CR SERIES RISOGRAPH

TECHNICAL INFORMATION

DATE: JUNE 1999	ISSUE NO. CR001 Our ref: CRT-004

SUBJECT: 020-12416-108 Rear Frame; Drum
020-12455-006 Actuator Plate; Drum Safety SW

DURING MACHINE SHIPMENT

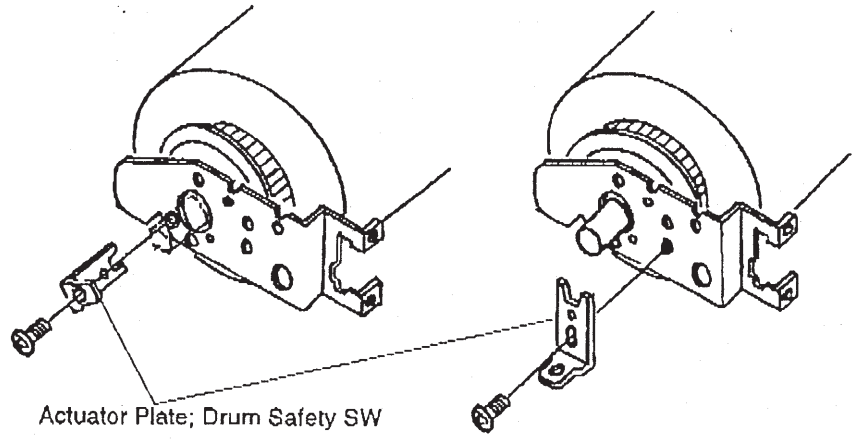
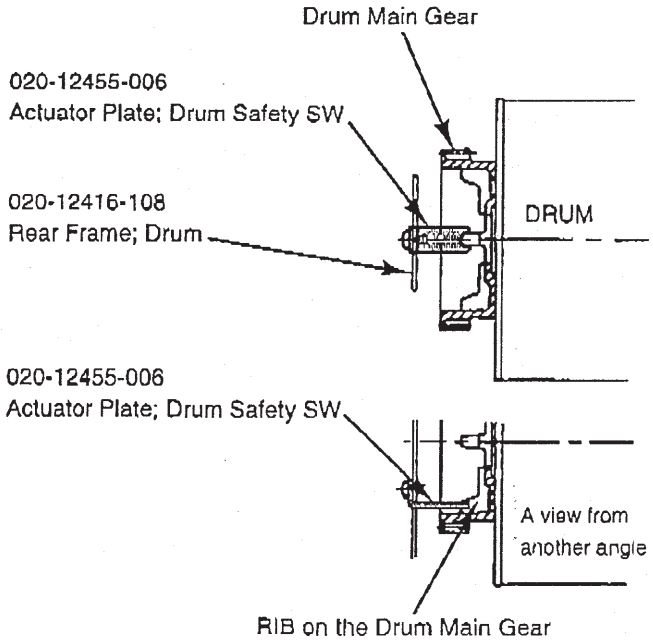
The drum rear frame was modified.
The drum safety switch actuator plate, which was formerly in one piece with the drum rear frame is now separated into an independent part.
On the new drum, the actuator plate is screwed onto the drum rear frame.

The drum safety switch actuator plate now has two functions.
One is to prevent the drum from rotating inside the machine during the machine shipment. For this function, the tip of the actuator plate is hooked on the rib of the drum main gear to keep the drum fixed at position-B.
After the installation of the machine, the actuator plate needs to be transferred to a second position on the drum rear frame for its second function. The second function is actually the main function of the actuator plate, which is to press against the drum safety switch to activate the switch.
All CR inkless drums have the actuator plate already installed in the "second function" position, when shipped from our factory, ready for normal printing job.

This cutout and the bent portion to activate the safety switch is removed from the new part.

Two tap holes are made.

A "V" cut is made, with a tap hole next to the "V" cut.

When CR machine is shipped:
During the shipment of the machine from Japan, "020-12455-006 Actuator Plate; Drum Safety SW" is attached onto the drum rear frame in the position as shown on the left drawing.
The forked end of the actuator plate is locked on the rib of the drum main gear to prevent the drum from rotating within the machine.
Since the actuator plate is not attached in the position to press the drum safety switch, the machine will not run without changing the position of the actuator plate.

1. Slide the Drum unit out from the machine.
2. Remove the Actuator Plate; Drum Safety SW as shown above figure "During Machine Shipment".
3. Put the Actuator Plate; Drum Safety SW onto the Drum Frame as shown above figure "During Nomal Printing Operation".
4. Put the Drum unit back into the machine.

お願い／Notice／请看下

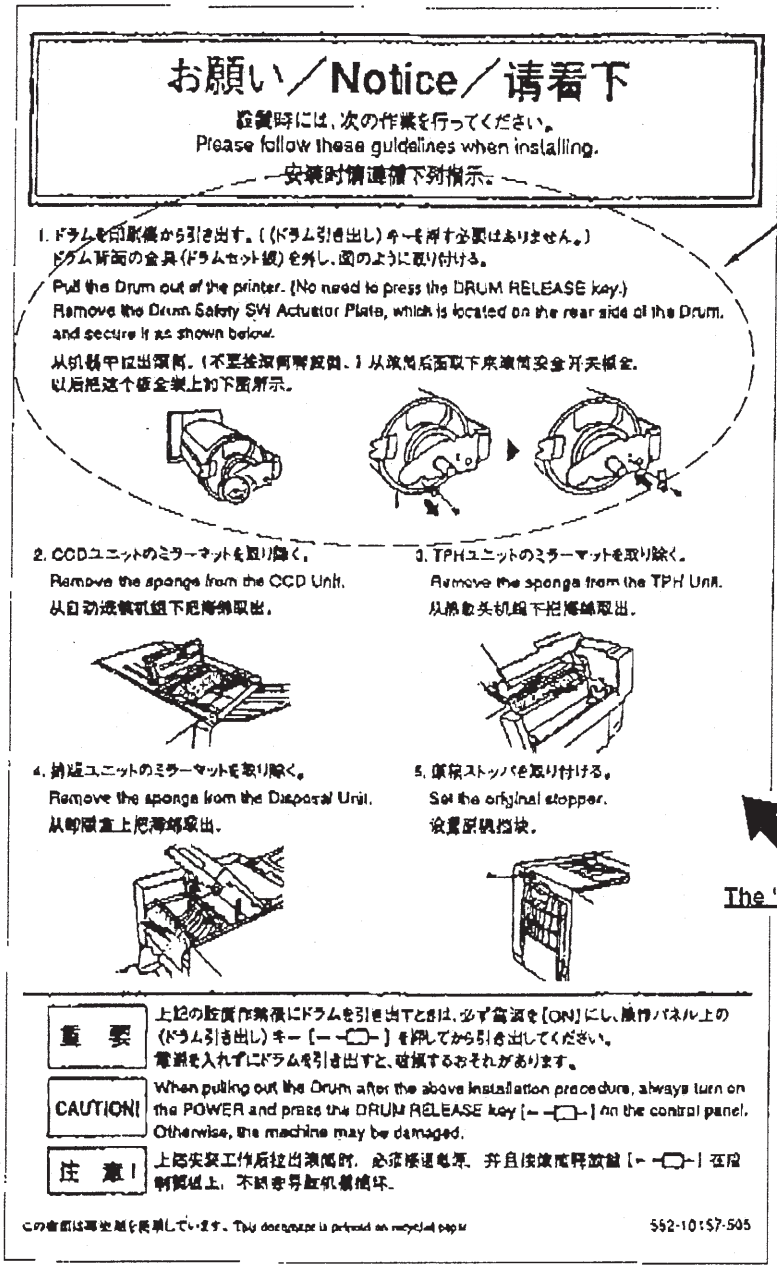
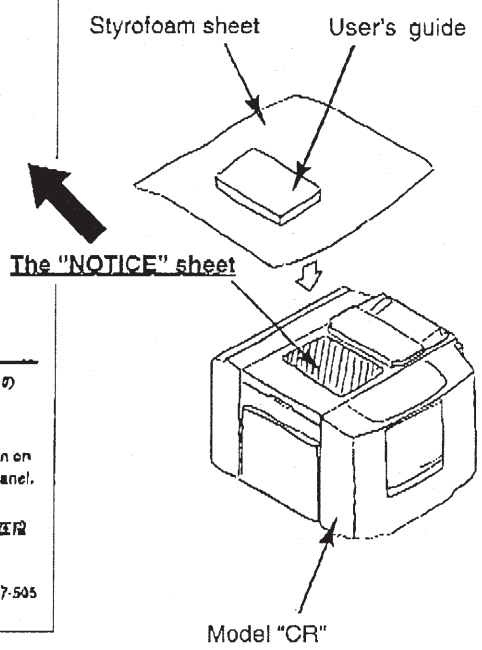
As mentioned on the previous page, a "NOTICE" sheet is included within the box of the machine.
Where circled on the left is the explanation on the positioning of the actuator plate.

1. ドラムを印刷機から引き出す。(〔ドラム引き出し〕キーを押す必要はありません。)
ドラム背面の金具(ドラムセット板)を外し、図のように取り付ける。
Pull the Drum out of the printer. (No need to press the DRUM RELEASE key.)
Remove the Drum Safety SW Actuator Plate, which is located on the rear side of the Drum, and secure it as shown below.
从机器中拉出滚筒。(不要按滚筒释放键。) 从滚筒后面取下滚筒安全开关板金，以后把这个板金装上如下图所示。

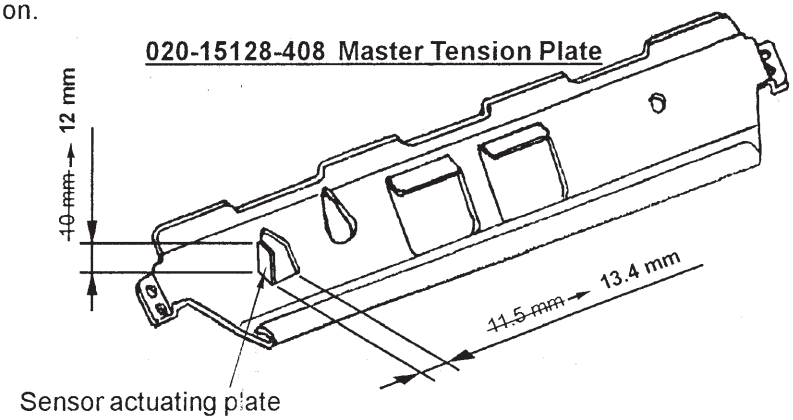
The System ROM of CR machines has been revised from version 2.02 to 2.03
The Master Tension Plate has been modified from 020-15128-308 to 020-15128-408.

The sensor actuating plate on the Master Tension Plate is elongated 2mm longer than previous part. Please refer to the figure below. This part must be used with System ROM CRS/V2.03 or later version.

The main reason of these revision is to prevent the error message "E-15".
To avoid mis-detection of the plate at its home position by the Master Tension Plate Sensor, the sensor actuating plate on the part is elongated. Due to revision of this part needs to revise the program, which explained on the above. This program revision enable the Master Tension Plate to ensure fully lock to its home position as well.

The Read Pulse Moter activation time (in the reverse direction) after the sensor detect the Master Tension Plate is extended from 10ms to 35ms.
This movement is on the process of lifting the Master Tension Plate to its home position after Master making process.

SUBJECT: MODIFICATION OF "FB SCANNER AREA"

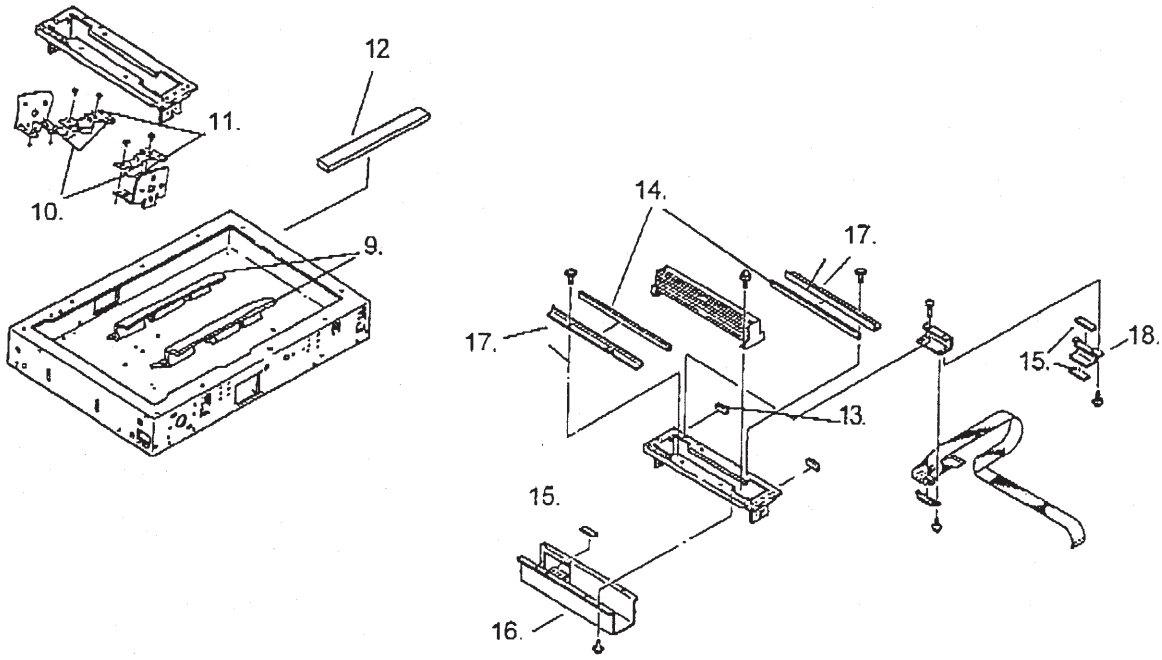
* For improved protection from electromagnetic interference, the design of the scanner holder area has been changed on picture panel models, as described on the next page.
* Due to the change of connector on the Image Scanner and Flat Bed PCB, parts have been changed in the Scanner area as described below.

The following parts were added (changed) on the Picture panel models.

9.	019-16019-005			Rail; FB-Scanner
10.	019-16020-003			Ground Spring; Scanner Holder
11.	019-16021-000			Base Plate; Ground Spring
12.	019-16018-009	-	106	Guide; Image Flexible Wire

The following parts were removed from the Picture panel models.

13.	481-30020-006	Gasket;30
14.	481-30002-008	Gasket;318
15.	481-30005-007	Gasket;40
16.	019-16014-003	Image Scanner Cover (Down);CE
17.	019-16013-007	Image Scanner Cover (Upper);CE
18.	019-16017-002	Wire Harness Stand II;CE

SUBJECT: 020-11301-200 Main Gear
650-35200-007 Spring Pin; Main Gear

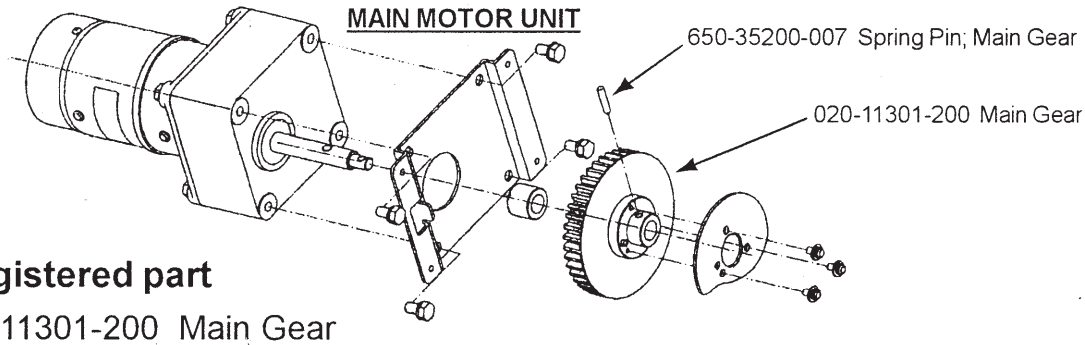
1. There were incidents in the past, in which the Main Gear needed to be changed. The only way in the past was to purchase the whole main motor unit.
2. There were another incident in the past, in which the Spring Pin became loose from the Main Gear. As with the other case, the whole main motor had to be replaced.

Note: When the Spring Pin becomes loose on the Main Gear, the hole for the spring pin on the main gear has usually become enlarged.
Therefore, when the spring pin is loose, it is best that both the Spring Pin and the Main Gear be replaced at the same time.

Important:
1. When forcing the Spring Pin into the Main Gear and the shaft of the Main Motor, make sure to rest both the main motor and the motor shaft on some solid object, so that the motor shaft does not bend when the Spring Pin is forced into the Main Gear and the motor shaft.
2. Apply ***plenty of grease*** on the teeth of both the Main Gear and Intermediate Gear when replacing either of these two gears.
